A17 Standards Committee Interpretations

Page
Interpretations Approved at the April 2000 A17 Standards Committee Meeting	2
Interpretations Approved at the June 2000 A17 Standards Committee Meeting	14
Interpretations Approved at the September 2000 A17 Standards Committee Meeting	20
Interpretations Approved at the January 2001 A17 Standards Committee Meeting	24
Interpretations Approved at the April 2001 A17 Standards Committee Meeting	27
Interpretations Approved at the June 2001 A17 Standards Committee Meeting	37
Interpretations Approved at the September 2001 A17 Standards Committee Meeting	48
Interpretations Approved at the January 2002 A17 Standards Committee Meeting	52
Interpretations Approved at the April 2002 A17 Standards Committee Meeting	59
Interpretations Approved at the June 2002 A17 Standards Committee Meeting	75
Interpretations Approved at the September 2002 A17 Standards Committee Meeting	85
Interpretations Approved at the January 2003 A17 Standards Committee Meeting	93

CASE 1

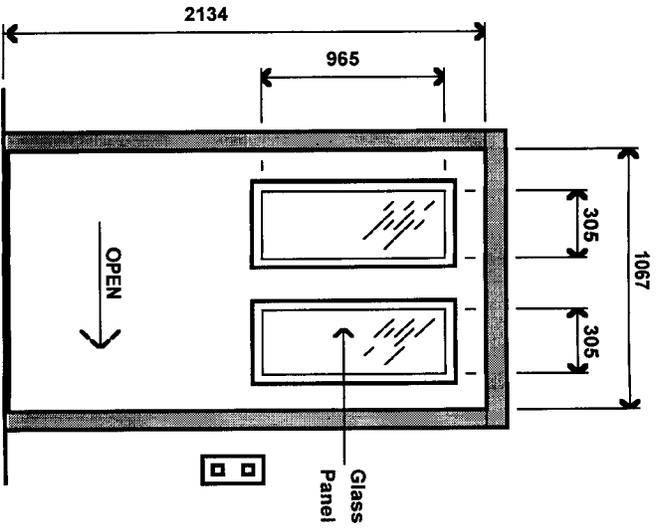
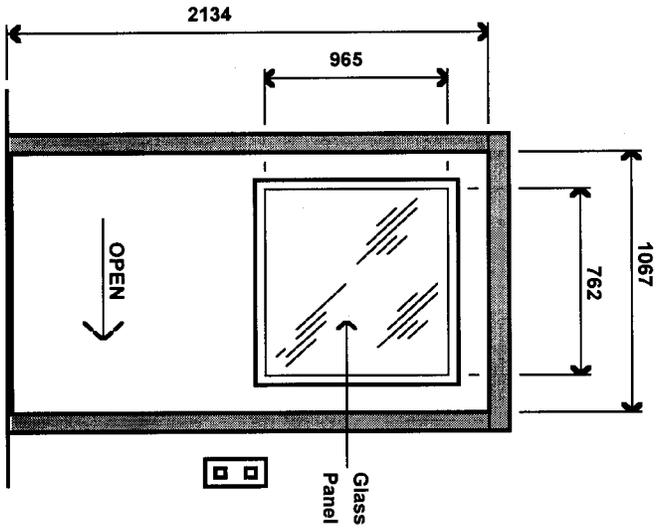
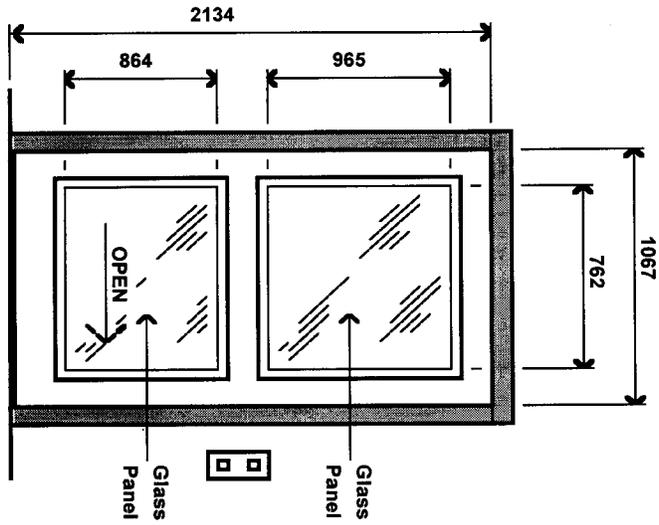
The following questions are based upon the attached sketches:

- 1) Is case 1 compliant to Rule 110.7b(3)?
- 2) Is case 2 compliant to Rule 110.7b(3)?
- 3) Is case 3 compliant to Rule 110.7b(3)?

Wheelchair Lift / Floor Penetration

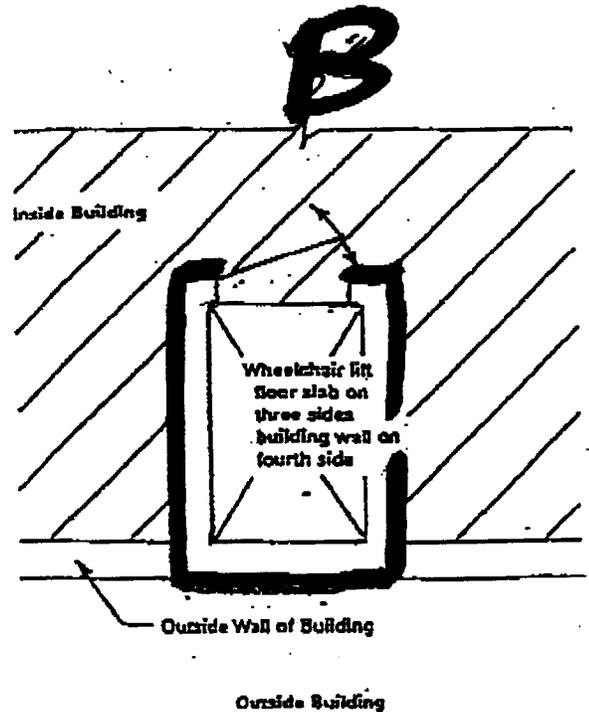
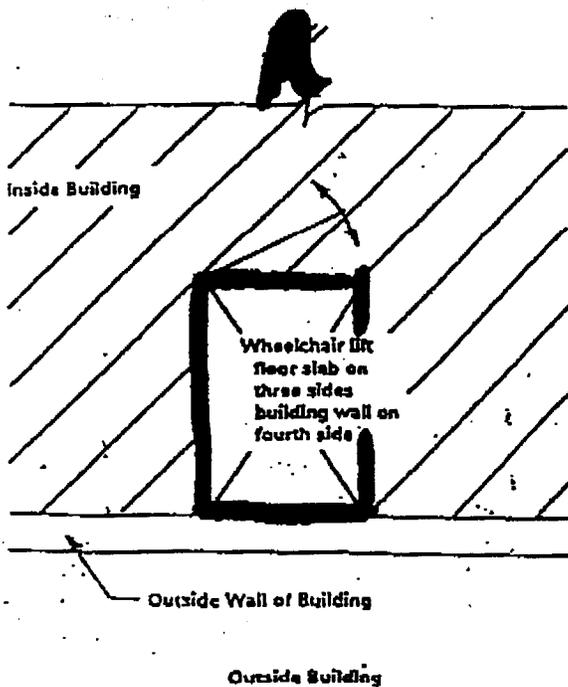
1. If a lift goes through a second floor or higher will the floor be penetrated?
2. If a vertical wheelchair lift is in an enclosed hoistway does the four contiguous sides include the walls of the hoistway?
3. In diagram "A" below, where the exterior wall is one of the four contiguous sides of the open hoistway is there floor penetration?
4. In diagram "B" below the exterior wall is part of the hoistway enclosure is there floor penetration?

- 1) Please refer to the definition of Penetrate a floor in Section 3.
- 2) No. See answer to question (1).
- 3) Yes. See Inquiry 94-25.
- 4) Yes. See Inquiry 94-25.

Subject: Rule 100.6(b)(4)
Setbacks in hoistway enclosure walls

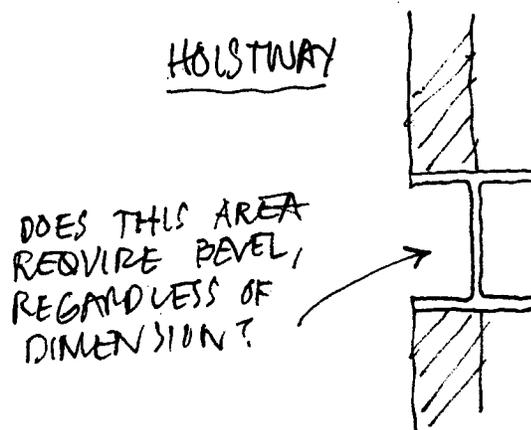
Question: Rule 100.6(b)(4) requires the tops of setbacks in hoistway enclosure walls to be beveled at an angle of not less than 75 degrees with the horizontal. Is this intended to apply to the setback of a beam web from the edge of the beam flange, if the beam flange is otherwise flush with the hoistway enclosure wall? (See drawing)

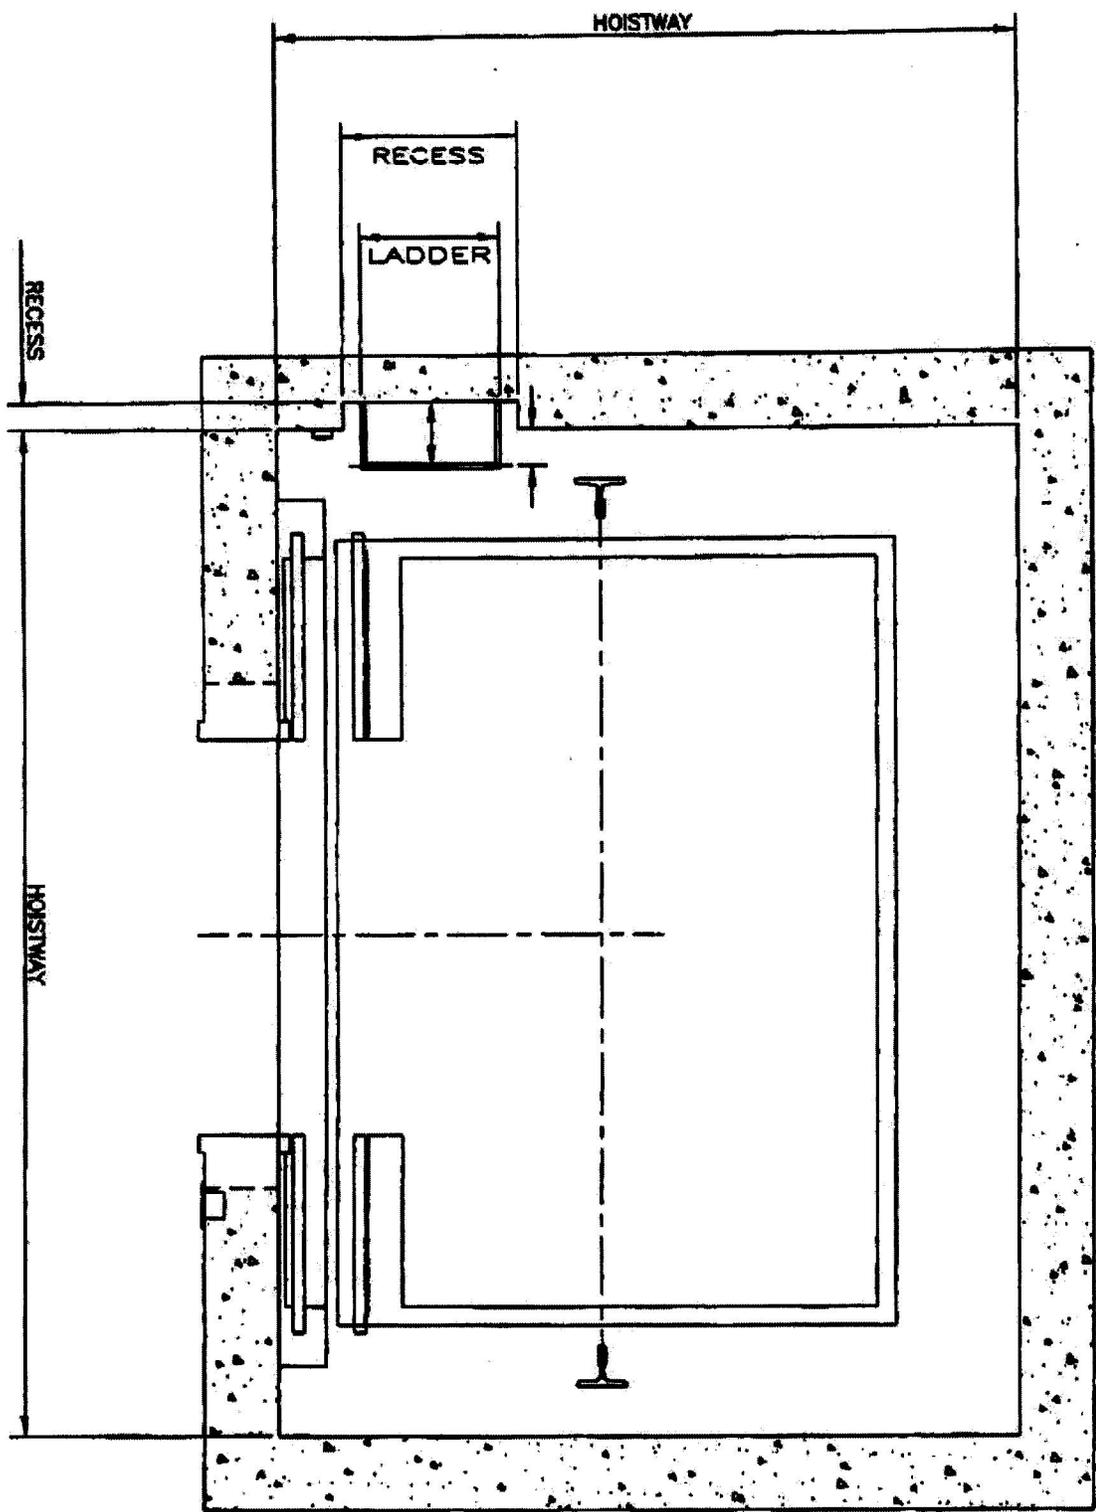
US Navy and USCG have standardized the wire rope type to be used on elevator systems other than traction type to be nominal 6x37 - IWRC (independent wire rope core) construction.

- 1) Does paragraph 7.5.6.1 permit IWRC [Independent Wire Rope Core] construction wire rope in lieu of Elevator Wire type construction [typically Fiber Core type]?
- 2) Are there types of wire rope construction that are not allowed or not recommended?
- 3) If a dumbwaiter or material hoist utilizes a traction type machine, shouldn't the wire be Elevator Wire type construction, and should paragraph 2.20.1 be invoked?
- 4) Should both paragraph 2.20.1 and 7.5.6.1 be revised to address the types of machines being supported in a consistent manner? Should specific types of wire rope be specified for traction machines and specific types of wire rope be specified for winding drum machines?
